SUBJECT: GEOTECHNICAL REVIEW OF SEISMIC SAFETY MARGIN STUDY

Plant Name: Big Rock Point Nuclear Power Plant
Owner/Licensee: Consumers Power Company
Docket Number: 50-155
Responsible Branch: SEPB, T. Cheng, LPM
Document Reviewed: D'Appolonia, April 1982 - "Report on Parametric Study,
Soil-Structure Interaction, Big Rock Point Nuclear Power
Plant, Charlevoix, Michigan," A report for Consumers
Power Company

Geotechnical Review of Seismic Safety Margin Study
Big Rock Point Nuclear Power Plant
Charlevoix, Michigan

Fig. 1. TYPICAL REDUCTION OF SHEAR MODULUS WITH SHEAR STRAIN FOR TILL
 AT BIG ROCK POINT SITE

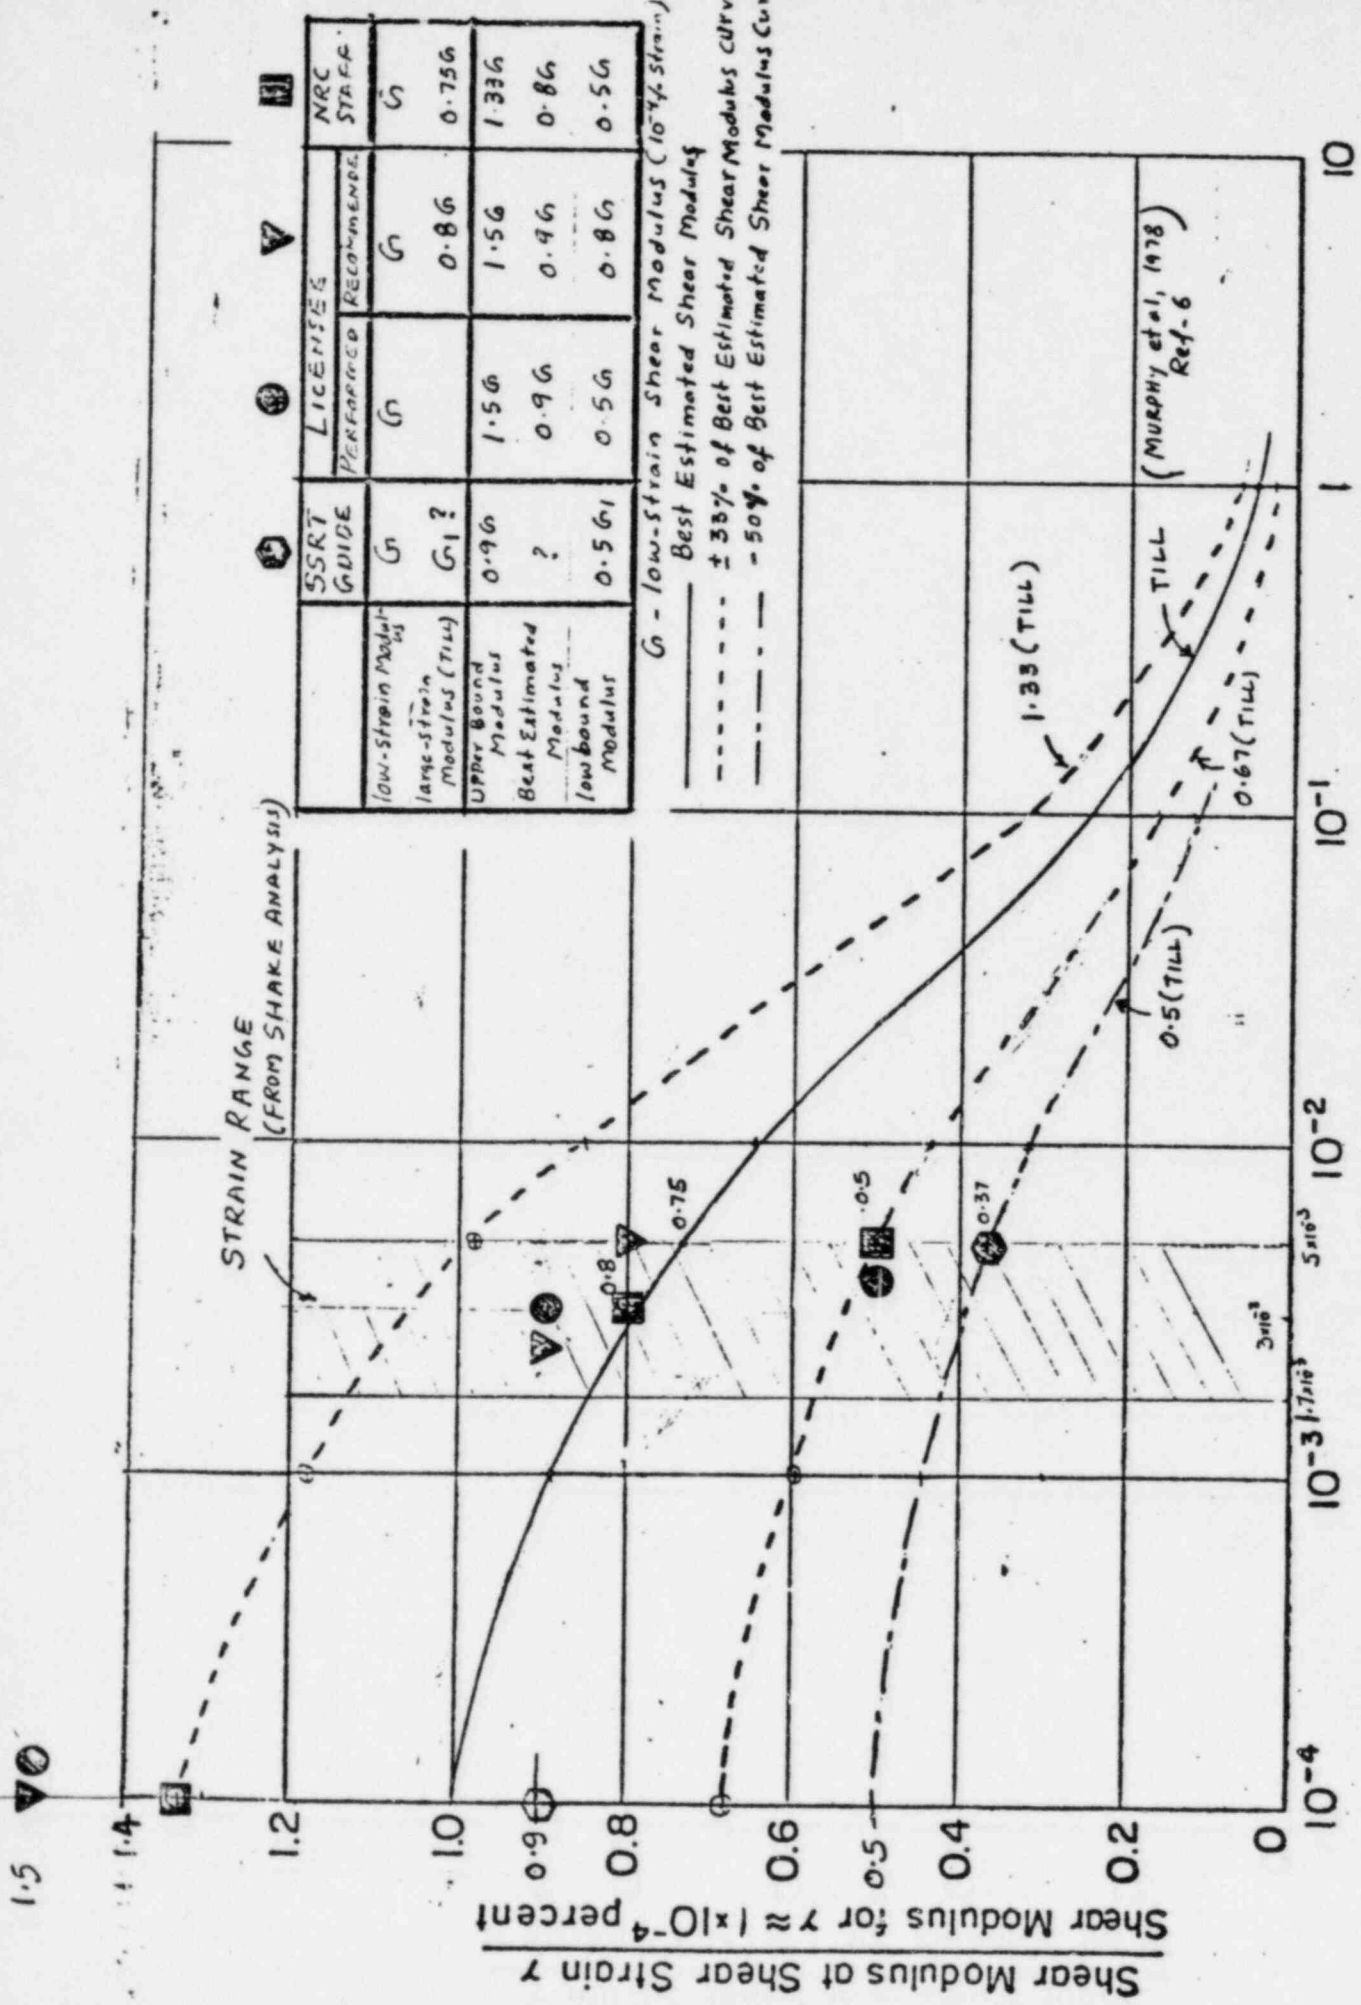
Figure 1 shows the range of shear modulus values to be used in the analysis as per the above recommendations. Generally, the modulus determined from field geophysical tests (cross-hole survey) is considered as a low-strain ($10^{-4}\%$ strain) modulus. Large-strain is the maximum strain in the soil estimated for the seismic design conditions.

Licensee has performed SSI analyses using the above range of shear modulus. The low bound shear modulus value used (50 percent of the low-strain shear modulus) is not in compliance with the SSRT guidelines (50 percent of the large-strain shear modulus). The licensee states that 80 percent of the low-strain shear modulus is a reasonable representation of the low bound value of the shear modulus, and that 50 percent of the large-strain shear modulus is an extreme low bound value, considered very unrealistic for the BRP site.

Figure 1 shows the range of shear modulus investigated by and recommended by the licensee.

For this soil (till), the reduction in the shear modulus is approximately 10 percent at a shear strain of 10^{-3} percent and is approximately 25 percent at a shear strain of 5×10^{-3} percent, based on Murphy et al 1978, Reference 6. The staff recommends that the reduced shear modulus for the large-strain condition at BRP site (shear strain 5×10^{-3} percent) should be about 75 percent of the low-strain modulus.

1. The staff does not agree with the licensee's statement that 80 percent of the low-strain modulus is a reasonable representation of the low bound value of the shear modulus at BRP.
2. The shear modulus for the large-strain condition is expected to be about 75 percent of the low-strain modulus at the BRP plant.
3. The SSI parametric study should envelope ± 33 percent variation from the best estimated shear modulus vs shear strain curve (See Figure 1).
4. The low bound shear modulus which was used for this soil is 33 percent less than the large-strain modulus.
5. The licensee's parametric study included a ± 50 percent variation of low-strain shear modulus; this envelopes the range of values of the shear modulus estimated by the staff. Figure 1 shows the staff's recommendation of the range of shear modulus values to be used in the SSI analyses at BRP.

parametric study may be limited to a 33 percent reduction in shear modulus rather than the 50 percent reduction recommended in the SSRT Guidelines.
